Oak Park Green Streets Retrofit Project

Additional Discussion and Considerations

Oak Park Municipal Advisory Council

Biofilters

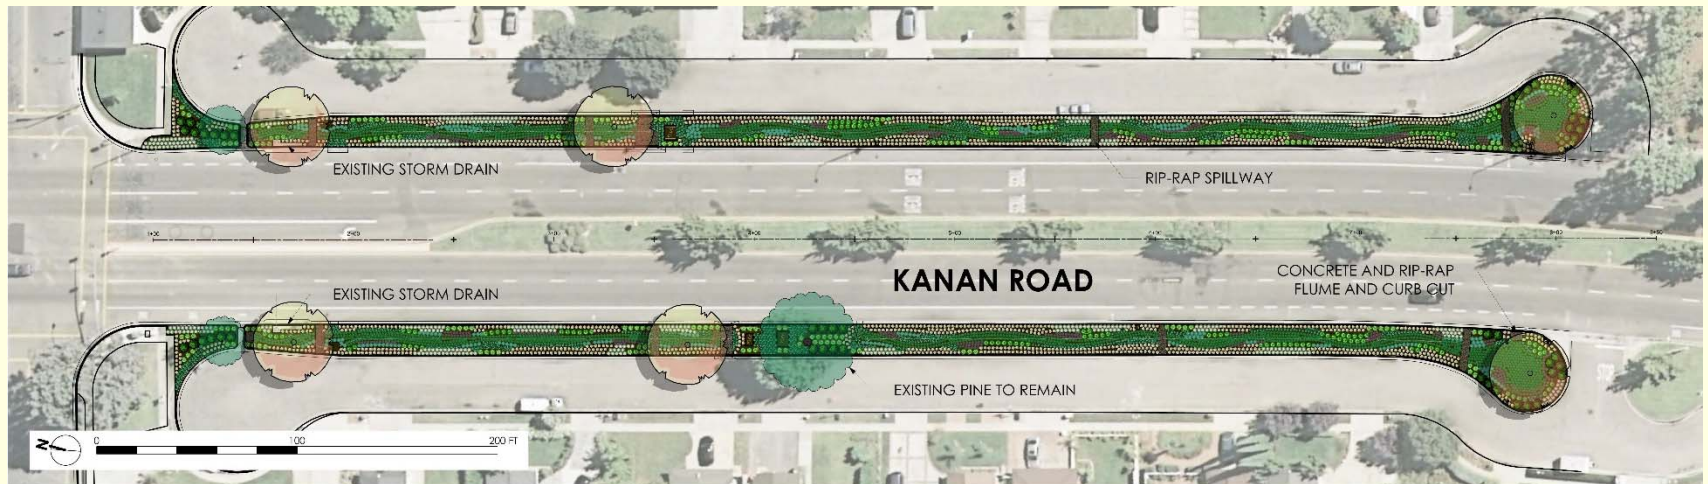
COMMENT: Project requires removal of about 30 ornamental trees in the median at Kanan Rd (estimated replanting cost \$7,500)

No.	Request	Response
1	Replant the removed trees within the medians	Revised design to include 2 Signature Oaks and additional trees within 6 forebays of the biofilter.
2	Replant the removed trees in the front yards of properties along the biofilter sites (outside of right-of-way)	The removed trees will be replanted depending on property owner's interest. The property owner will need to maintain and take any future liability for the trees.
3	All plants to be at least 1 gallon size for planting	Plugs changed to 1 gallon size

■ Proposed Biofilters ● Oaks ● Sycamore Trees

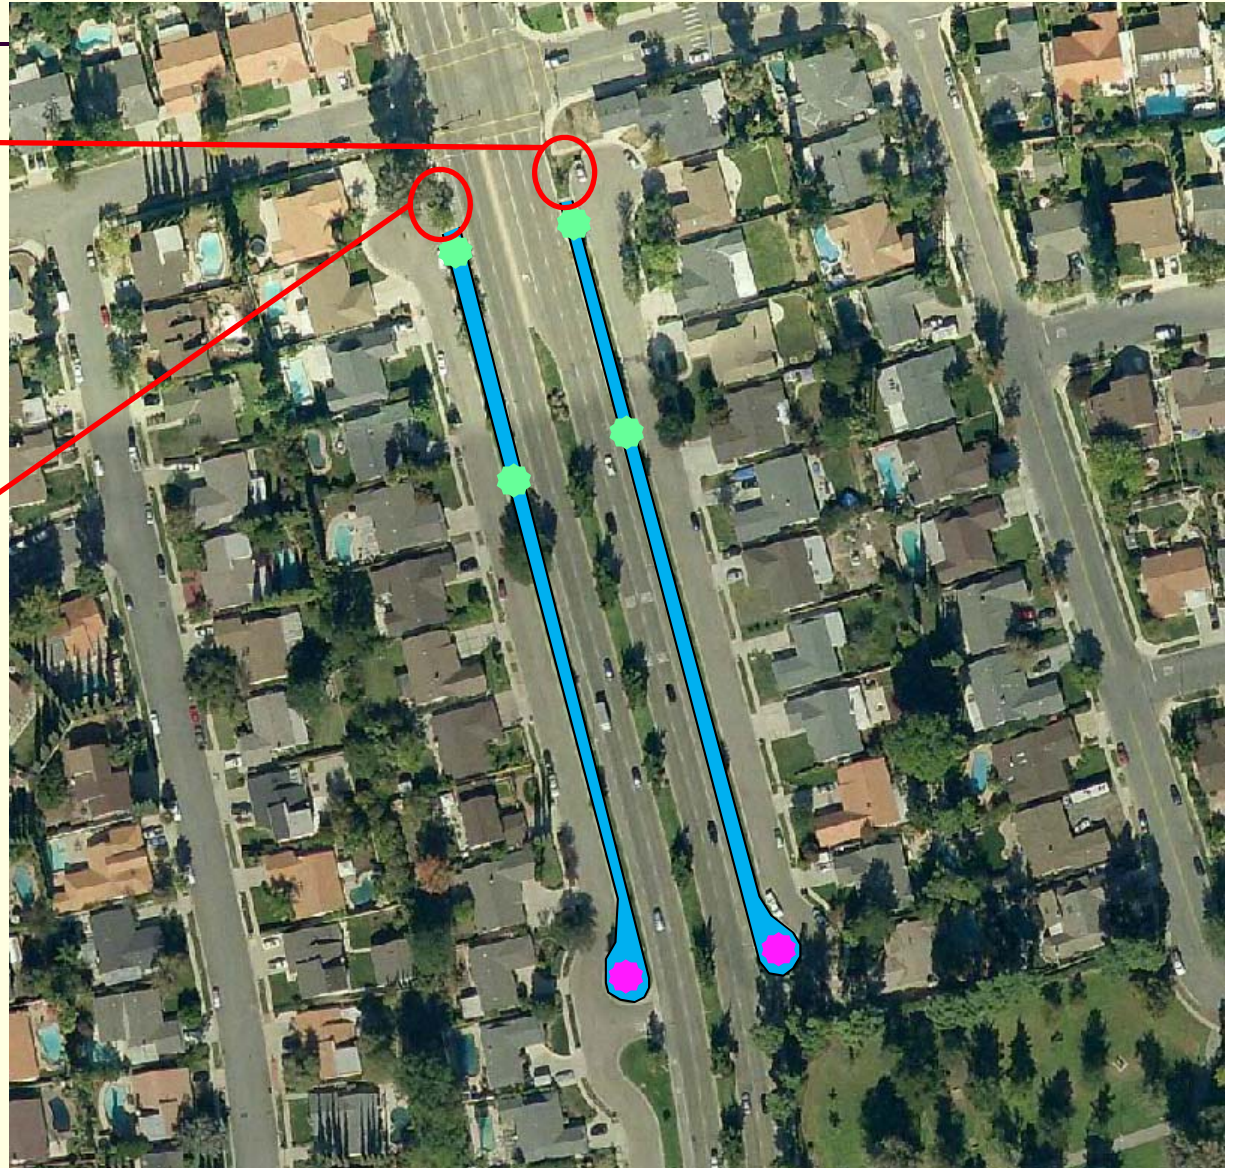
No.	Comment	Response
4	Aesthetic impacts at the main entrance to the community	<ul style="list-style-type: none">➤ Design was altered to allow for 2 Oaks and additional trees to be planted;➤ Landscape Architect expanded plant list that meets project design goals and adds varying color and height options;
5	Lack of CEQA review. OPMAC member doubts CEQA exemption	<ul style="list-style-type: none">➤ Categorical exemption for a retrofit of existing facilities within County's Right-of-Way (<i>Existing Facilities, Sec. 15301 and Replacement or Reconstruction Sec. 15302</i>).
6	Landscape Committee member wants to see data that supports need for project, design of project, efficacy of project, for where it is planned	<ul style="list-style-type: none">➤ Multiple presentations to the OP MAC were given since 2010;➤ Additional doc is available upon request including TMDL reg's, Implementation Plan, Technical Memo and Reports; Hydrology & Hydraulics Report
